**KANE PACKAGE PHILIPPINE INC.**

INVESTIGATION REPORT FORM (IRF)

Customer	ARKRAY	Attention To	REXEL ALMARIO
Item Code	84-05467A	Department	PRODUCTION
Item Description	INNER BOX F821629-1	Date of Detection	250305
Job Order Number	JO25-M-00773-1	Section Detected	QA SCREENING 5

ILLUSTRATION OF THE PROBLEM

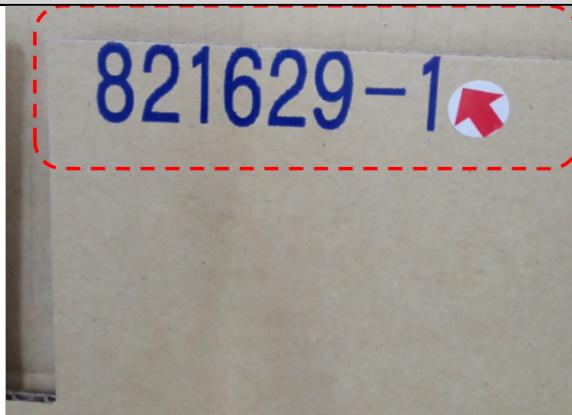
MISALIGN PRINT

7 mm (Tolerance: ± 3 mm)

Print within the cutting line

WHY 1 : Movement of print during process

WHY 2 : Delayed timing/feeding of boards

WHY 3 : Warp materials

WHY 4 : Lacking of weight jig

WHY 1: Provision of weight jig to prevent warpage of materials. Existing Paper weight jig already disposed as per advice of Top management ME // 2025-06-15
